PROPOSED RESIDENTIAL
DEVELOPMENT AT TKOTL 70RP,
PHASE 11. LOHAS PARK, TSEUNG
KWAN O. N.T.

Factory Inspection Report 01

Report Reference: 60646872-FI-R-01

19_Water leakage was found inside spandrew backpan

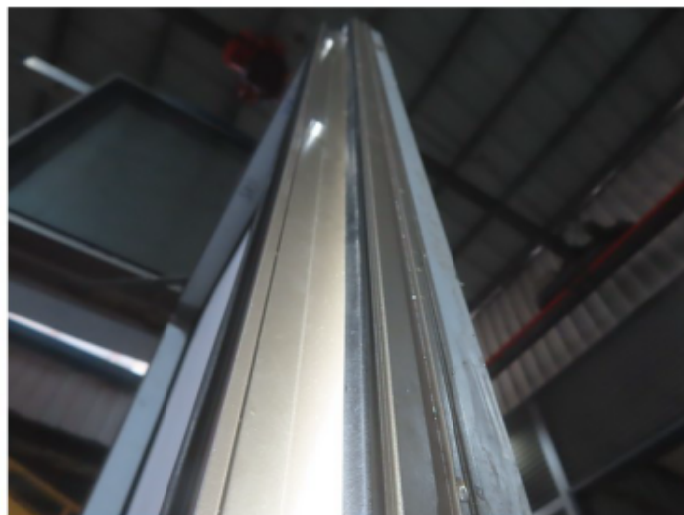
Action: MIDI is required to carry out their internal QA/QC method to repair the leakage unitized panel, MIDI needs to improve workmanship for

20_Damage sealant was found at end position of mullion

Photo 12

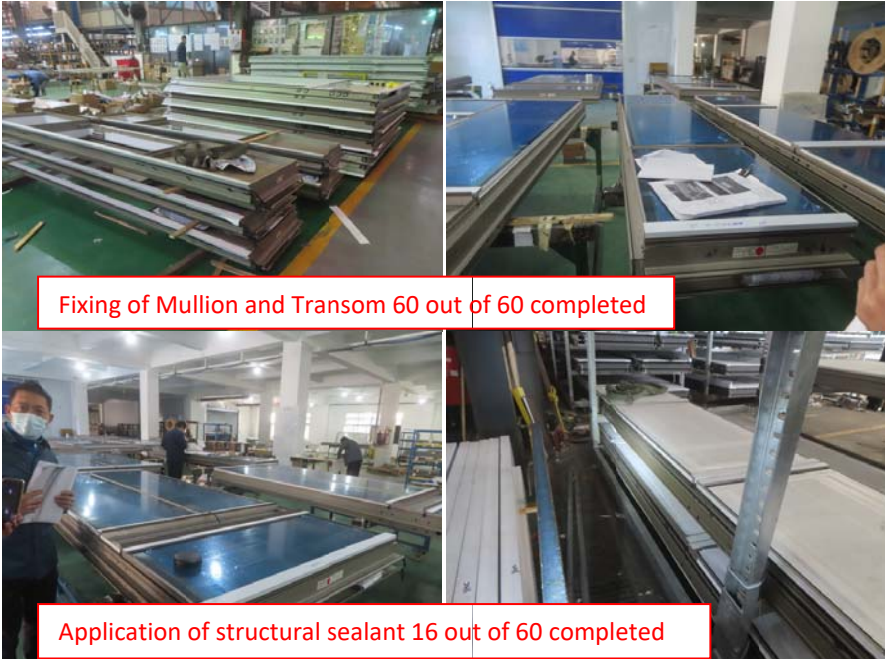
Description:
Water leakage was found during flooding test for Panel number 16F-T1A-CW4_AS-10

Action:
- MIDI is required to carry out their internal QA/QC method to improve workmanship for future works

Photo 6

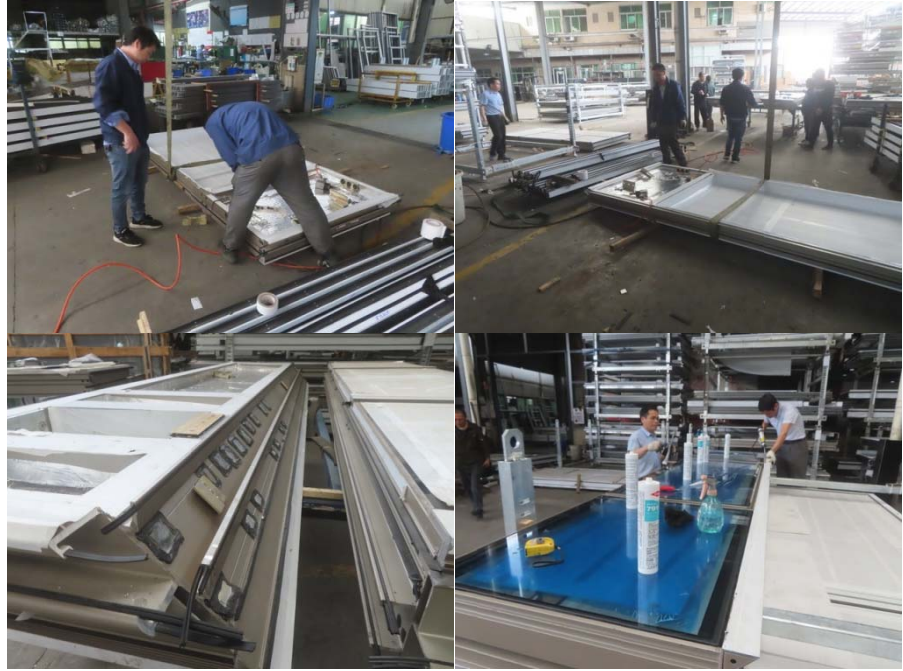
Gasket of unitized panels for Zone M01 & 02 were found not match with design drawing

-MIDI is reminded to carry out the remedial works prior products delivery and to improve workmanship for future works

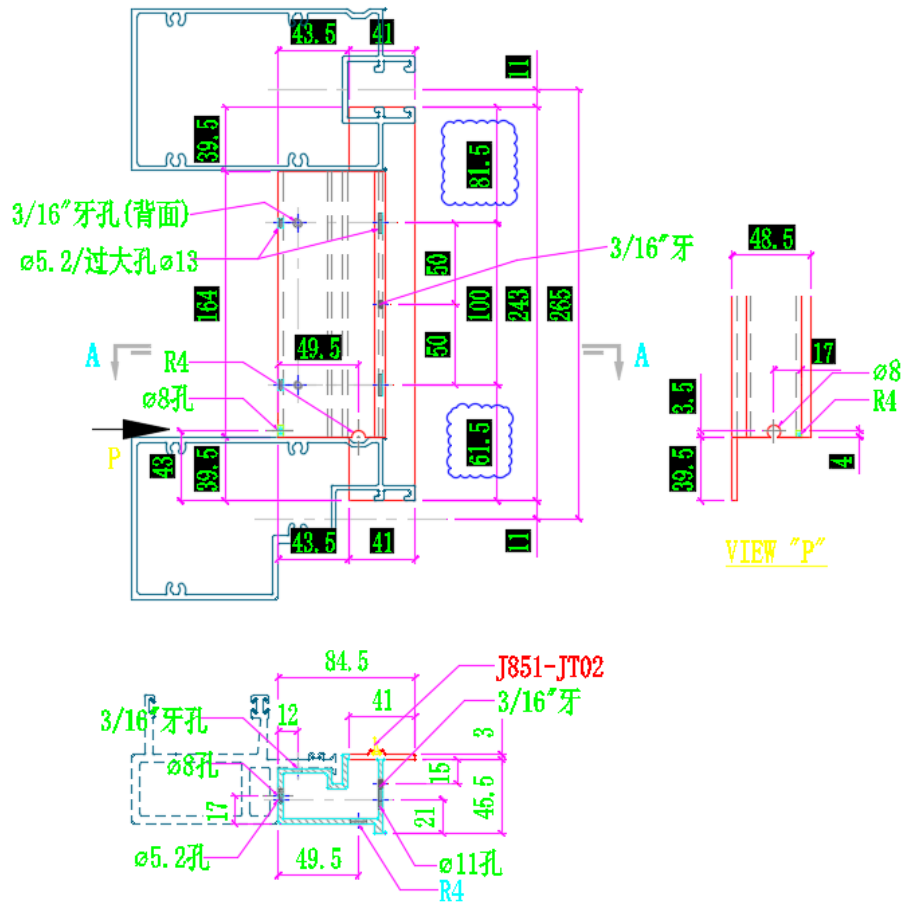
云線內的尺寸為修改項

回覆：工廠已由設計人員修改加工圖及車間已加排水孔（詳見圖片）

Photo 10

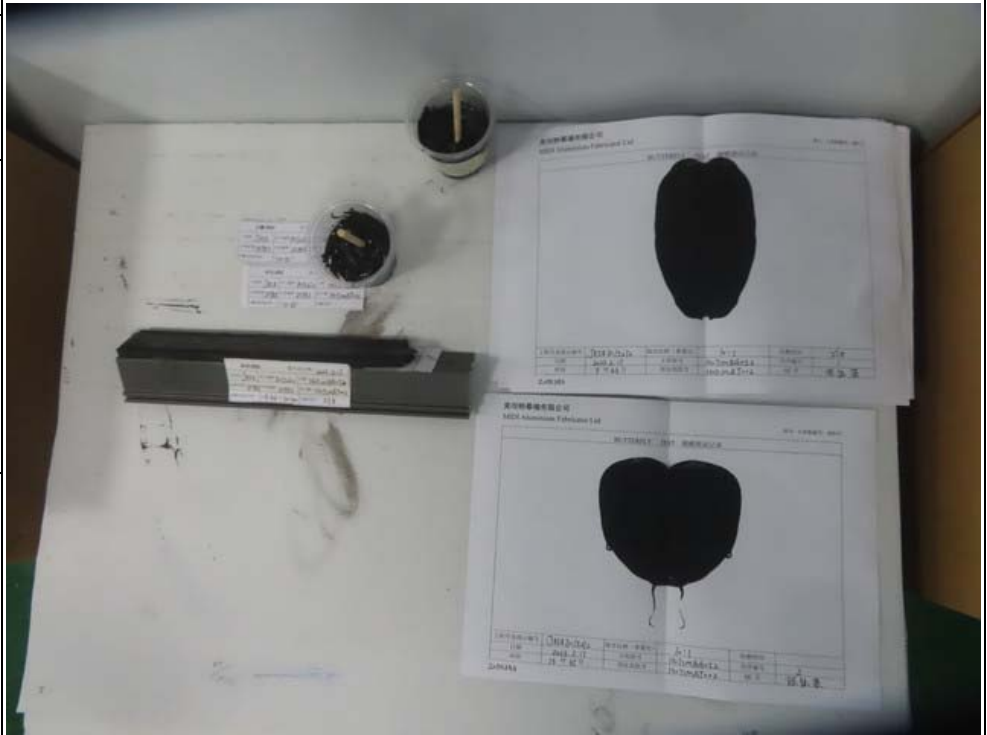
Description:
Defective sealant for 2nd & 3rd log unitized panels were found during final inspection and packing

Action:
- MIDI is reminded to carry out the remedial works prior products delivery and to improve workmanship for future works

Blemish and scratch at middle layer of IGU

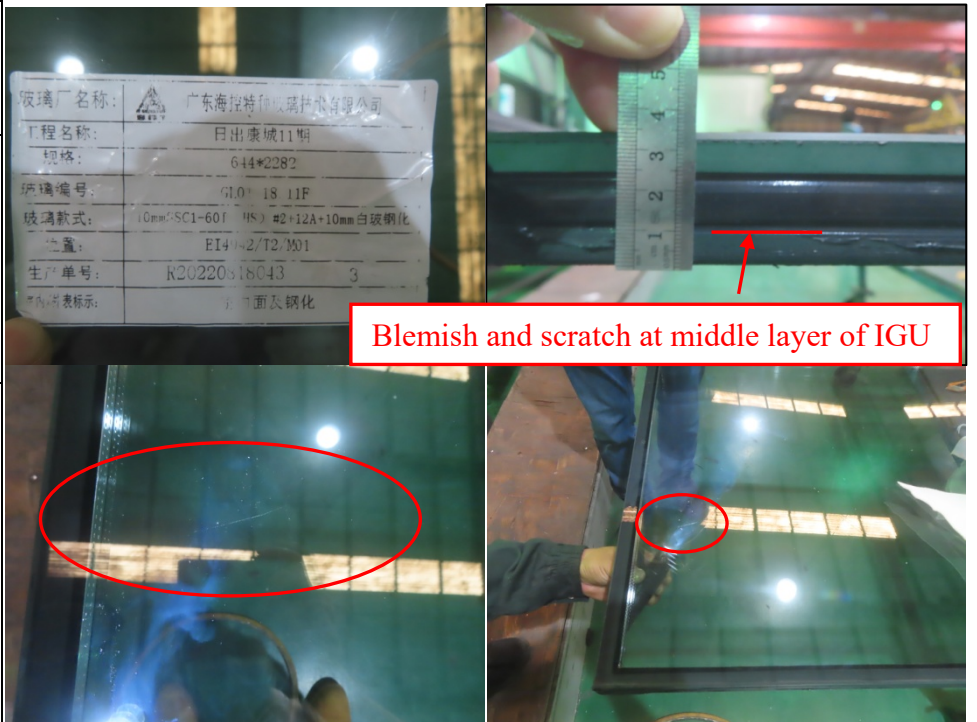
Description:
Blemish and scratch was found at middle layer of IGU

Action:
- MIDI is required to improve workmanship for further works
